**SUBJECT: MAIN LANDING GEAR RETRACTING LINK BOLT REPLACEMENT**

MODELS AFFECTED: M20F - S/N 660003 thru 22-1439; M20J - S/N 24-0001 thru 24-0609

FIGURE 212-1

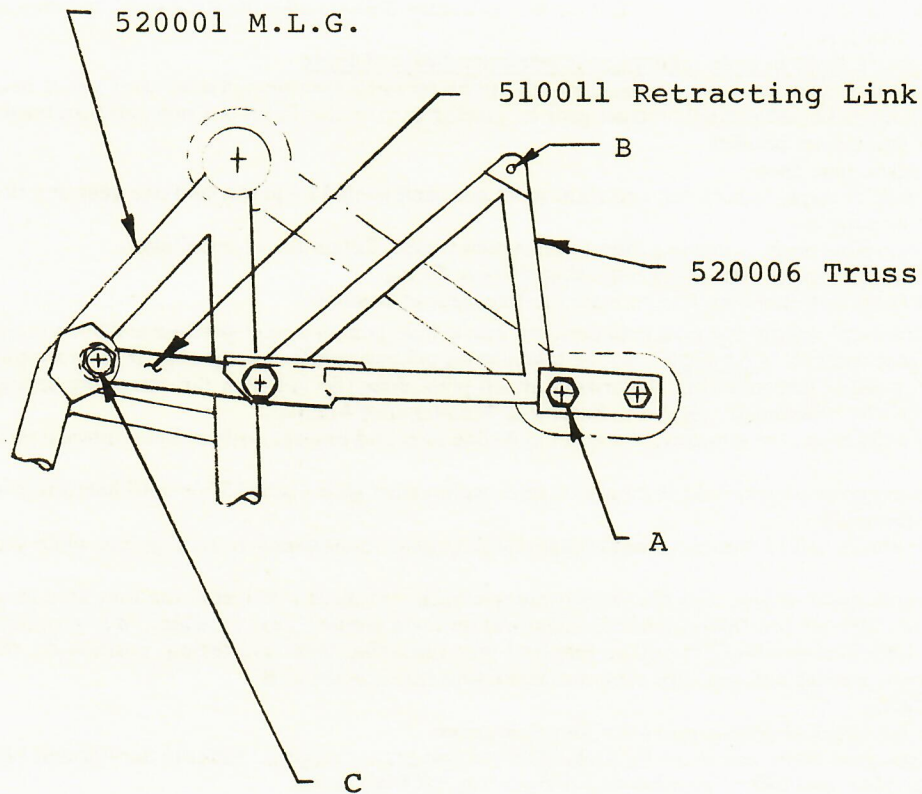
INTRODUCTION: To prevent the possibility of failure of the main landing gear side brace during adverse ground conditions the side brace bolts are to be replaced for greater capabilities.

NOTE: Steps 3 thru 12 apply to both left and right main gear and should be performed one gear at a time. Refer to Figure 212-1 for proper orientation.

3. Remove bolt at position B, attaching tube to retraction truss. Retain for re-installation.

4. Remove bolt at position A, attaching retracting truss to fitting.

5. Remove nut from bolt attaching link to main landing gear at position C.

8. Install NAS 1306-29 bolt (2.3 inches long) in main landing gear re-attaching retracting link while gear is held in canted position.

10. Install new AN 363-624 nut (and washer as required) on main landing gear attaching link, position C.

11. Install NAS 1306-20H or 1306-21H bolt as required thru retracting truss and fitting, position A. (Re-safety wire).

12. Re-install bolt, washer and nut thru tube and retracting truss, position B.

- A. Remove AN6H-17A or 914006-503 bolt.
Install NAS 1306-21H or 1306-20H bolt
as required.
- B. Retain hardware for re-installation.
- C. Remove AN6-22A bolt.
Install NAS 1306-29 bolt (2.3 inches long)
and new AN 363-624 nut.
